RESOLUTION HOLDING HEARING ON REQUEST FROM EASTGATE PLAZA, LLC FOR APPROVAL OF A PROPOSED 7TH AMENDMENT TO THE EASTGATE PLAZA PUD CONCEPTUAL PLAN ON PROPERTY LOCATED IN THE VICINITY OF 1534 EAST EUCLID AVENUE

Communication from the City Plan and Zoning Commission advising that at their February 3, 2022 meeting, the following action was taken regarding a request from Eastgate Plaza, LLC (owner), represented by Norman S. Weinstein (officer), for review and approval of a 7th amendment to the Eastgate Plaza PUD Conceptual Plan on the property located in the vicinity of 1534 East Euclid Avenue, to allow development of a 7,500-square-foot medical office building.

DAVITA EAST DES MOINES DIALYSIS
 AN AMENDMENT TO THE EASTGATE PLAZA P.U.D. (PLANNED UNIT DEVELOPMENT)
 CITY OF DES MOINES, COUNTY OF POLK, STATE OF IOWA
 SHEET 3 OF 3

EXTERIOR ELEVATIONS

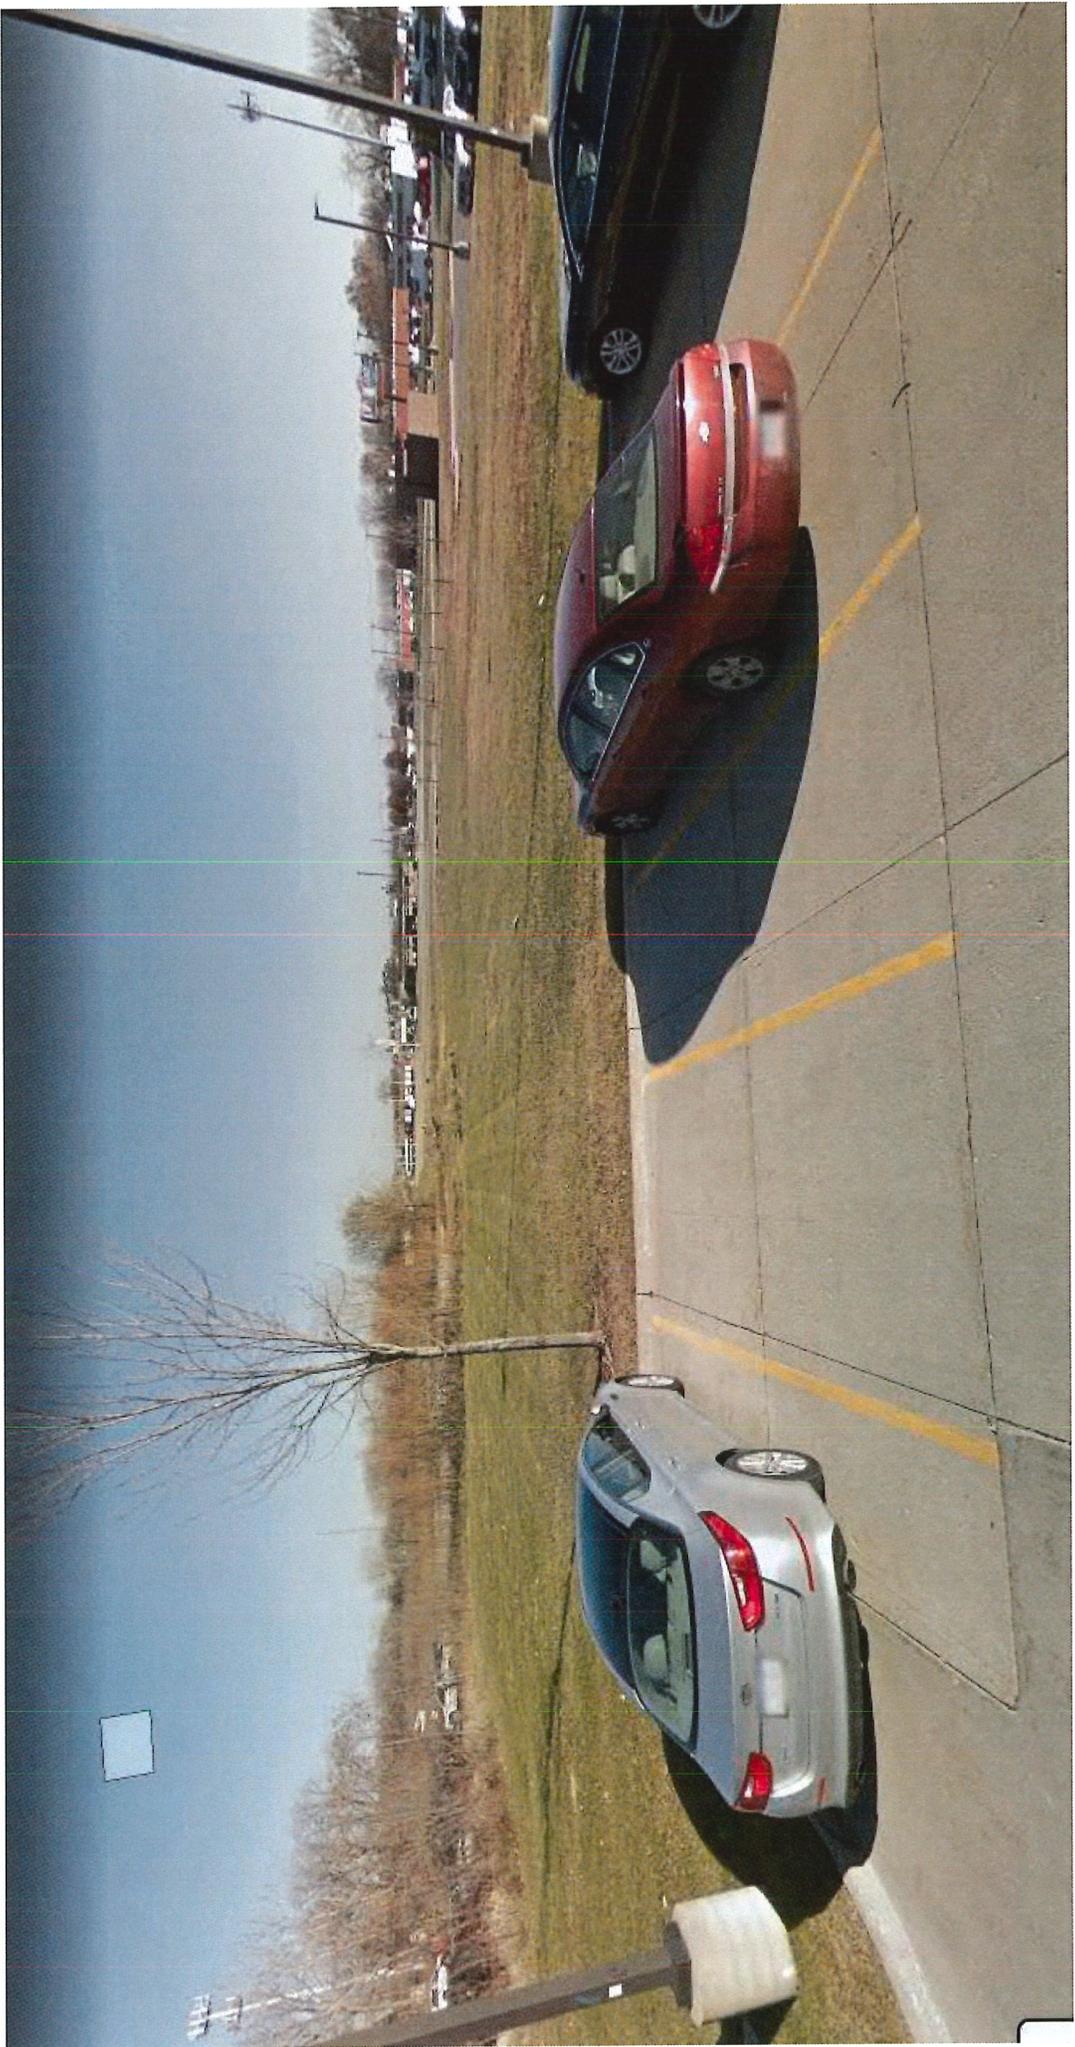
6. **Urban Design:** The proposed building would be sided with a mix of stucco with elastomeric finish (EIFS) and split-face concrete masonry units (CMU). Brick would be used as an accent material. EIFS is typically limited to the third floor or higher in commercial buildings (Section 135-4). Staff believes that the building should primarily be sided with materials that are classified as "Major Façade Materials" by Chapter 135 of the Municipal Code. In addition, the amount of transparency (windows) and the transmittance factor of the windows should be comparable to what is required by Chapter 135. To allow flexibility for the applicant and staff to work on design solutions during the development of the PUD Development Plan, staff recommends a general condition that points back to the standards found in Chapter 135.

- 5) Provision of a note stating that the building shall be sided with materials that comply with Des Moines Municipal Code Chapter 135, Planning and Design Ordinance to the satisfaction of the City’s Planning Administrator.

- 6) Provision of a note stating that windows and doors shall be provided that comply with the relevant transparency, transmittance and reflectance factors found Des Moines Municipal Code Chapter 135, Planning and Design Ordinance to the satisfaction of the City’s Planning Administrator.
